Review of recent slope stability studies at Snodgrass Mountain, Colorado

By Rex L. Baum
U.S. Geological Survey
Box 25046, M.S. 966
Denver, CO 80225-0046

Administrative Report
8 January 2009

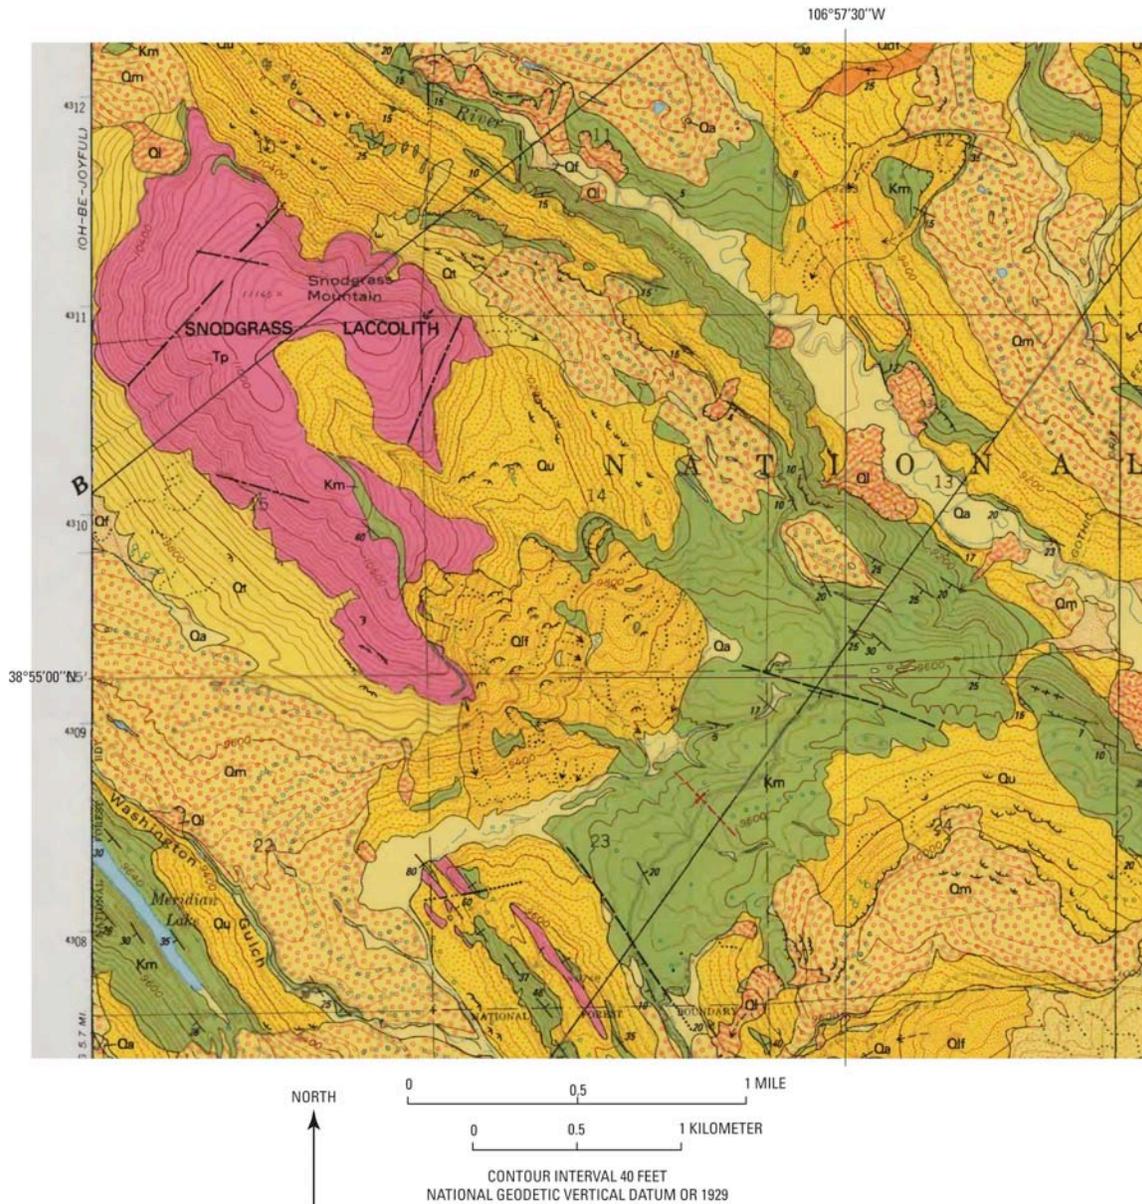
9. Field checking to verify the absence of landslides on the East Facet (GHU 7), and the absence of landslide features in the southwestern part of GHU 12 (the steeply sloping area between Snodgrass Road and the northeastern border of GHU's 3, 5A, and 6; see fig. 2).

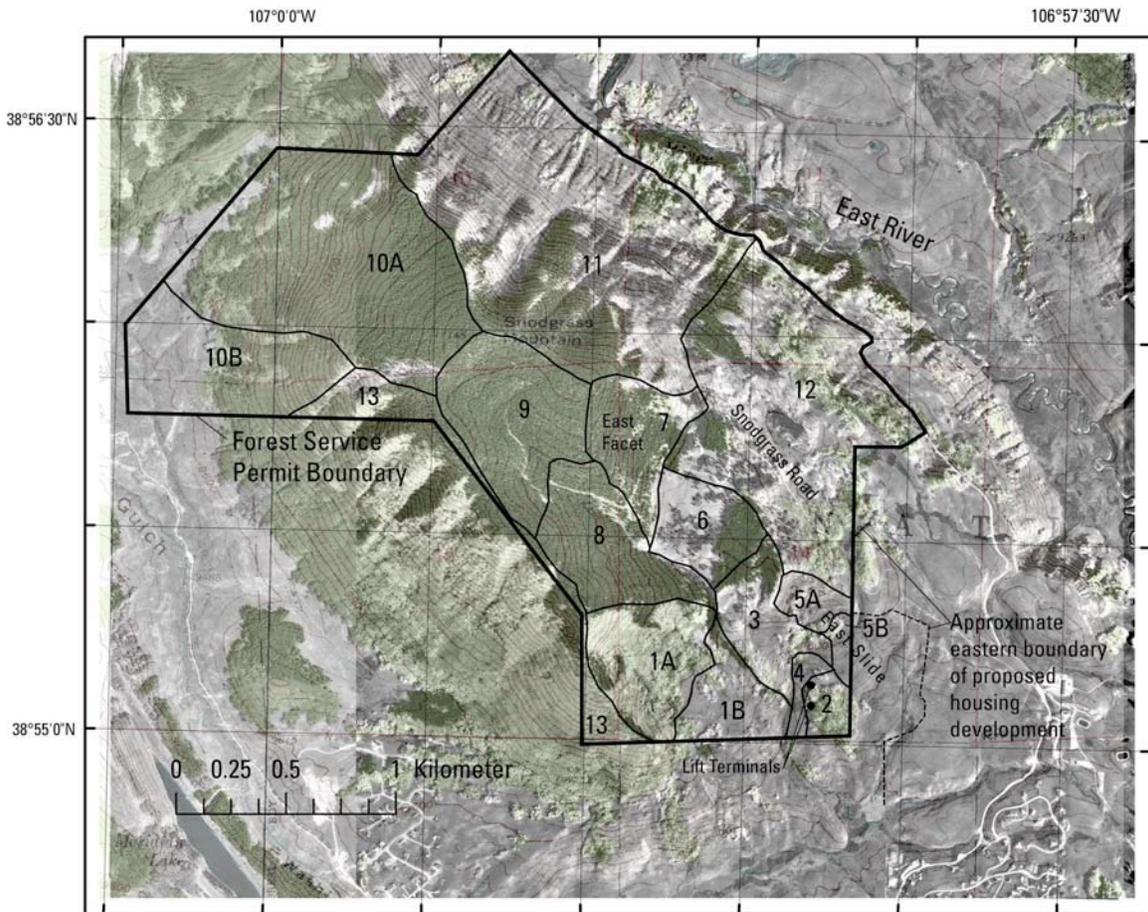
2. **Unacceptable Damage.** The report discusses the level at which resource damage would be unacceptable, but the discussion is somewhat incomplete (USDA Forest Service, 2006, p. 68–69). One scenario leading to severe or unacceptable damage, based on a Forest Service criterion for logging and other land uses, is damage to 15 percent or more of a "treatment area." The report concludes that severe damage to the permit area would result in the event of coordinated movement of multiple landslide areas or GHU's comprising at least 15 percent of the permit area. However, the report expresses uncertainty about how the "treatment area" should be defined—the entire permit area or only the portion that is disturbed. Timeframe for the damage is not mentioned, but severe damage might result from cumulative effects over time of many smaller events as well as one large event occurring in a short time. The report further defines impacts as moderate or severe in the case of landslide reactivation or new landslides depending on size or type. Impact of a rapidly moving landslide, such as a debris flow, rock slide, or rapid earth flow would be severe (USDA Forest Service, 2006, p. 69). A large slide or slump (of any speed), occupying 15 percent or more of the "treatment area" would be severe. The number of fatalities, injuries, or magnitude of offsite impacts that would be considered unacceptable is not stated. Offsite impacts were not considered, but the report notes that landslides in the southeast part of the permit area continue offsite, further downslope. For example, the East slide continues downslope toward the edge of the proposed residential development (fig. 3).

Comment. Clarification of standards, even if only qualitative, for acceptable risk with regard to landslide-related resource damage, injuries and fatalities, and off-site impacts, would facilitate Forest Service decision making and contribute to public confidence in the permitting process.

8. **Debris Flow Potential.** The proponent considers debris flows or rapid earth flows similar to the 2001 Gold Link landslide on Mt. Crested Butte unlikely (section 8.5.2, GEO-HAZ Consulting, Inc., 2008). Nevertheless, a low debris flow deflection berm was proposed to help protect two lift terminals on the lower part of Snodgrass Mountain (fig. 9-2, GEO-HAZ Consulting, Inc., 2008).
Comment. Data are insufficient to support this claim. As I have noted elsewhere in this report, historical occurrences under similar conditions on Mt. Crested Butte suggest that such flows are likely post development. No berms were offered to protect wetlands west of the lift terminals nor residential areas from potential debris-flow sources farther downslope and east of the lift terminals (fig. 3).
